2. CASE 26.004, 10 BARNES STREET, Double House, 1857-95 (COLLEGE HILL

Applicant/Owner: Prospect Street LLC, 220 Waterman Street, Providence, RI 02906

Proposal: The scope of work proposed consists of Major Alterations and includes:

10 Barnes St.

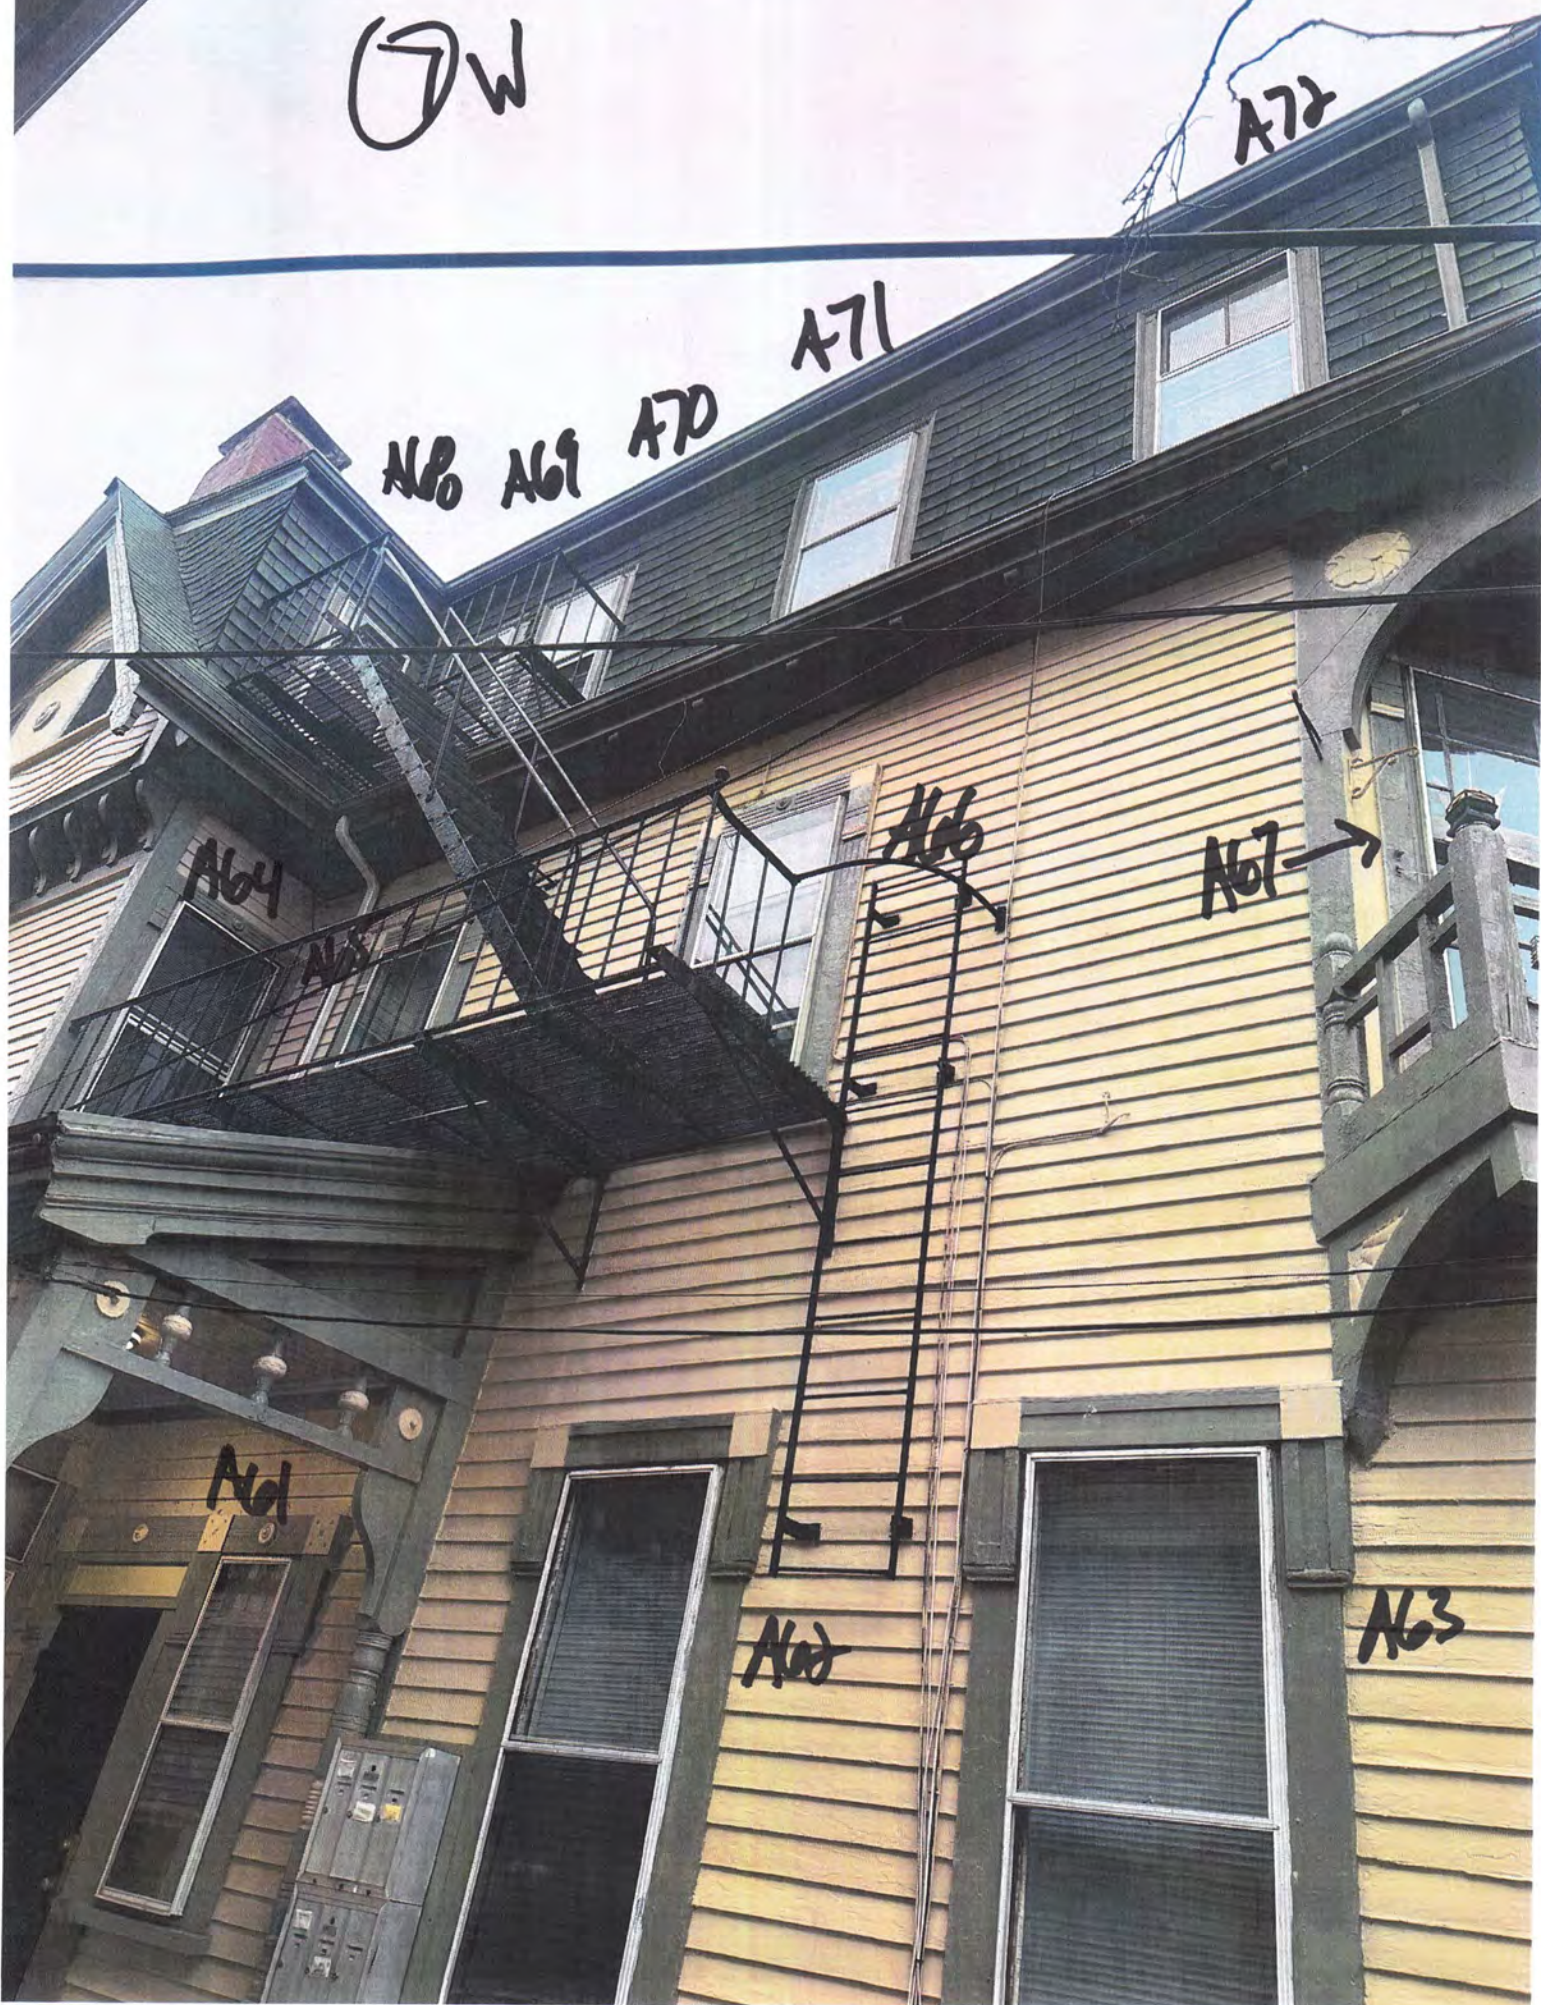
- The applicant is requesting the removal of the existing windows and installation of a preapproved window (United 9600). The issue is that the property has unique fenestration, particularly at the first-floor level (8/1 in a horizontal pattern with two panes/three panes/two panes and one pane in various sizes in the upper sash); It is economically unfeasible to restore the existing sash (and make lead safe) and/or replication the pattern in a new window. The applicant and staff have worked together extensively on researching this. Staff suggested that the second-floor pattern, which is also rare, but not unique, be replicated for the first-floor. This is a Victorian cottage pattern with narrow lites along the sides and at the top. The other existing fenestration on the building is 2/2 or 1/1 based on window opening size. It is possible to fabricate the United 9600 in this sash, but the applicant and staff have some concerns as to the quality of that fabrication. The applicant has researched a Harvey window that may be a better solution and there will be two physical samples of a United and Harvey window at the meeting for comparison and consideration;

- b) The application for Major Alterations is considered complete; and,
- c) The work as proposed is in accord with PHDC Standards 2 & 8 as follows: the proposed alterations are appropriate having determined that the proposed construction will be similar in size and appearance to the existing, matching in visual features (Standard 2) and is architecturally and historically compatible with the property and district having an appropriate size, scale and form that while diminishing the historic quality of the property will not have an adverse effect on the property or district (Standard 8) while allowing the property to come into compliance with RIGL § 42-128.1-8.

Staff recommends a motion be made stating that: The application is considered complete. 10 Barnes is a structure of historical and architectural significance that contributes to the significance of the College Hill local historic district, having been recognized as a contributing structure to the College Hill National Register Historic District. The Commission grants Final Approval of the proposal as submitted having determined that the proposed alterations are appropriate as the proposed alterations will be similar in size and appearance to the existing, matching in visual features (Standard 2) and architecturally and historically compatible with the property and district having an appropriate size, scale and form that while diminishing the historic quality of the property will not have an adverse effect on the property or district (Standard 8) while allowing the property to come into compliance with RIGL § 42-128.1-8, citing and agreeing to the recommendations in the staff report, with staff to review any additional required details.
